BULLSEYE® seed tube

Kinze 2007 and newer Seed Tube Installation Bulletin

Figure 1

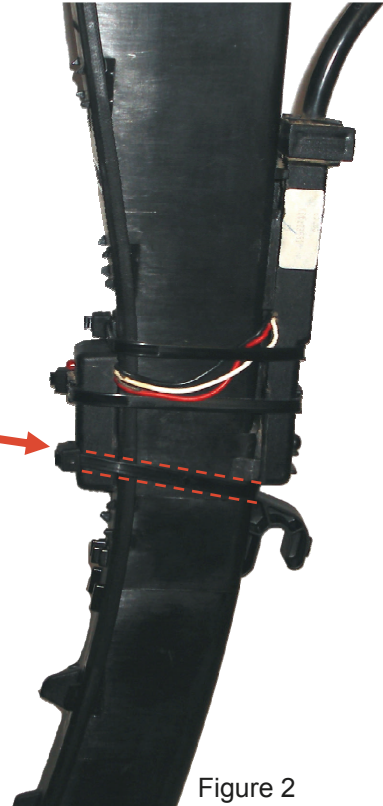
On some Kinze planters newer than 2006 the shank is narrower. Mount the sensor as shown below.

Figure 1 is how you would normally mount your Kinze sensor to a seed tube.

Note how the bottom zip-tie is attached.

Shank hit Zip-tie here.

Some newer Kinze planters have a narrower shank which can cause the bottom zip-tie to conflict as you install it onto the row as shown in figure 1. To solve this problem simply strap the bottom zip-tie lower on the side with the hook. This will keep it free from any conflict with the narrower shank as shown in figure 2. There are still two zip-ties securing the sensor to the tube so this alteration does not affect the stability of the sensor.

Figure 2 is how we recommend mounting the sensor to the seed tube.
